Evaluation of Crack Growth Rates for Alloy 690/52/152 and Alloy 600/82/182/132

NRC Meeting
February 15, 2018

The objective of this meeting is to present the EPRI MRP report on Alloy 690/52/152 PWSCC crack growth rates and provide clarifications and address comments on the report.

Materials Reliability Program: Recommended Factors of Improvement for Evaluating Primary Water Stress Corrosion Cracking (PWSCC) Growth Rates of Thick-Wall Alloy 690 Materials and Alloy 52, 152, and Variants Welds (MRP-386). EPRI, Palo Alto, CA: 2017. 3002010756.

Weld Interface and Dilution Zone Testing

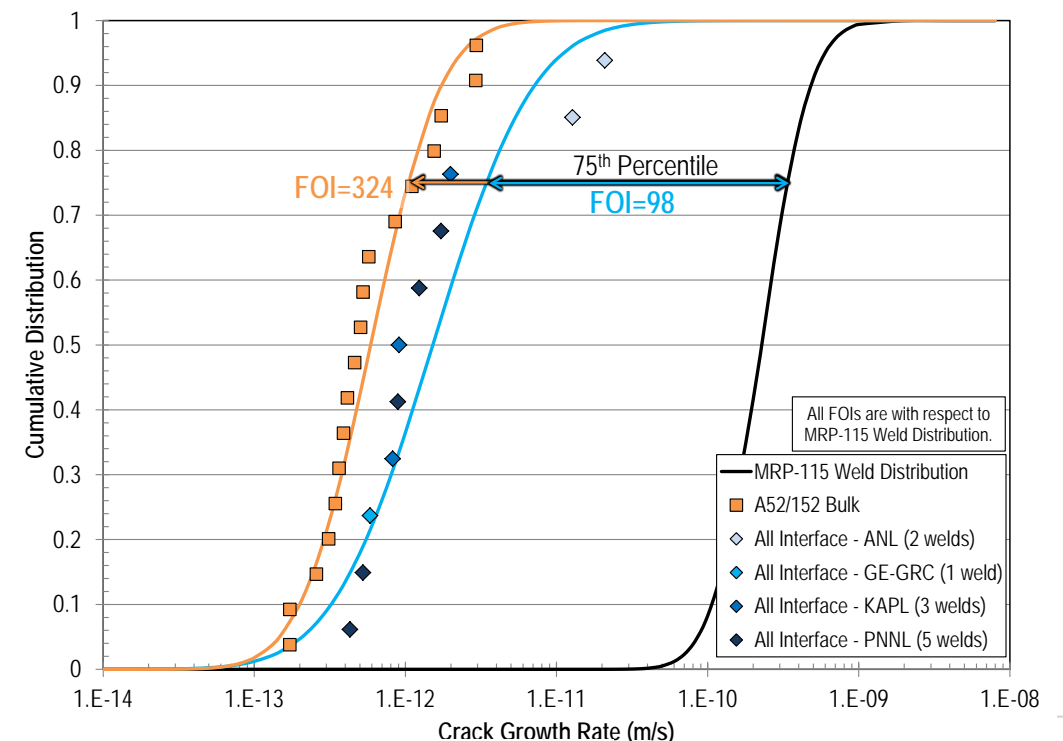
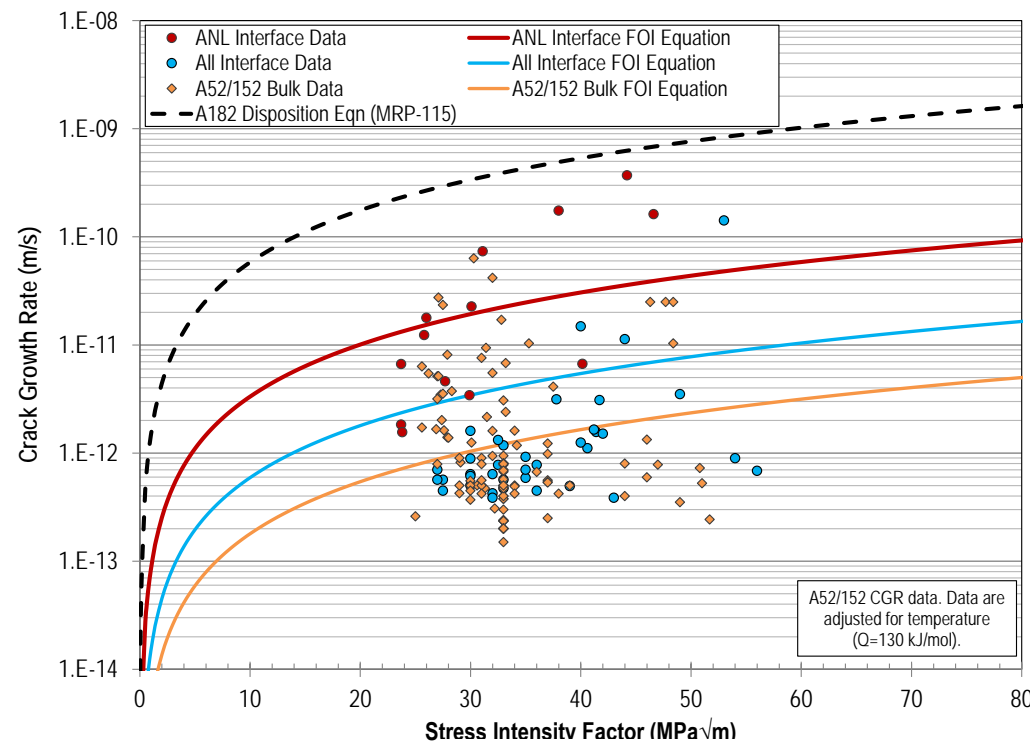
- Susceptibility of dilution zone (DZ) is likely affected by type of interface and welding parameters
- Microstructural features, such as localized high strain boundaries, could play an important role, but they are not well understood

- Addressed in Section 4.7.4 and Appendix G.7
- The Expert Panel decided that there were insufficient data available at the time to predict CGRs specific to Alloy 52/152 dilution zones/weld interfaces due to the wide variety of interface types and limited data for each (50 total points, 6 interface types)
- Instead, these sections describe the chromium dilution levels expected (based on mockups) and include data from the Environmental Degradation Conference 2017 (Toloczko) that show that there is generally no through-wall leak path through high strain boundaries
